## Deadline 2 Representation 2<sup>nd</sup> June 2021

**David and Belinda Grant, [REDACTED], Middleton-cum-Fordley, Suffolk. [REDACTED]**  
**Holders of 'Best Small Farm in Suffolk' and special award for 'Best Conservation' by SAA since 2019.**

This is our Deadline 2 Summary Representation together with Annexes to the Planning Inspectorate regarding the proposed Sizewell C nuclear development (SZC) currently before the Planning Inspectorate under DCO submission.

# Heritage Assessment

## OPTION A - INDICATIVE LONG SECTION

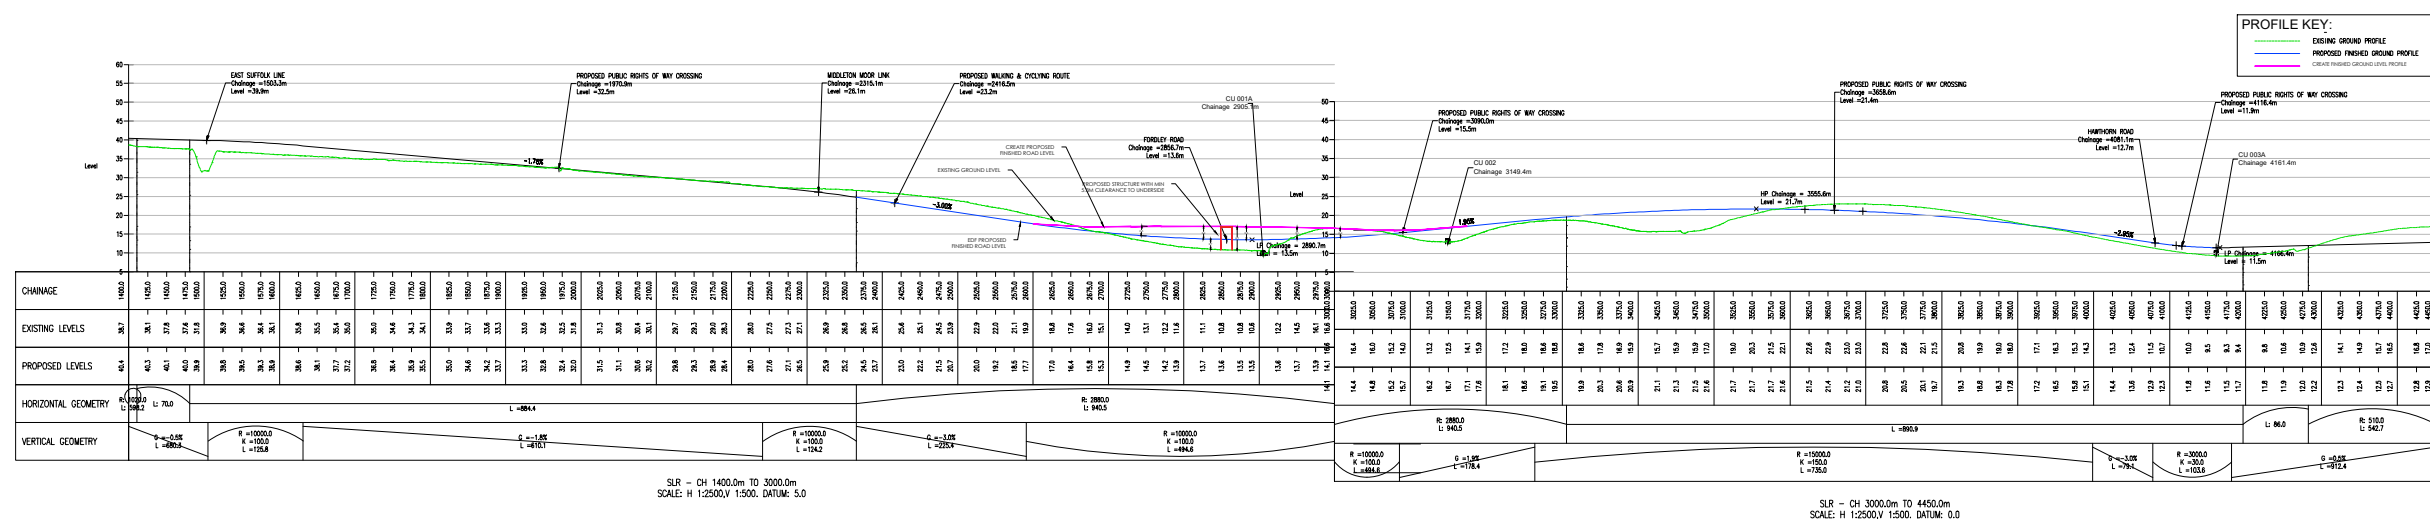
Therefore, Fordley Road must not be allowed direct access to the SLR; it needs to be retained to continue its current function of access to the B1122 for the local communities – hence our proposal to the Inspectors and the Applicant for Fordley Road to pass **below the proposed SLR**. Our consultants Create, confirm that this is not a great challenge from an engineering perspective and the SLR could then be reduced in width by 33% at the crossing point. Such a passage below the SLR could even be single track, with traffic lights to control directional traffic flow, whilst at the same time creating a permanent traffic calming measure.

Taking Fordley Road **under the SLR** will also provide access for emergency services to Middleton and Fordley communities (including the residential Nursing Home on Middleton Moor) in the event of closure of the A12 or an accident on the SLR itself.

- 4.2 Create have shown that the SLR / Fordley Road junction proposal is not safe for a number of reasons.
- 4.3 Create requests the Applicant revisits the Fordley Road link with a view to removing the SLR junction.

<b>Current EDF Proposal</b>	Cut off Fordley Road at the junction with the SLR and make access to the north of the SLR redundant from Fordley Road. Diversion requiring a 2km diversion route to access north side of Fordley road.	<ul style="list-style-type: none"> <li>• Cut off Fordley Road north of SLR</li> <li>• 2km diversion route created requiring northbound or southbound Fordley Road traffic to use SLR to access north side of Fordley Road</li> <li>• Cut and fill earthworks to build up ground profile</li> <li>• Earthworks to build up slip road</li> <li>• Divert waterway beneath SLR</li> <li>• Construct a turning head north side of Fordley Road to allow traffic to turn around</li> <li>• Cut off traffic flow along Fordley Road during construction phase</li> </ul>
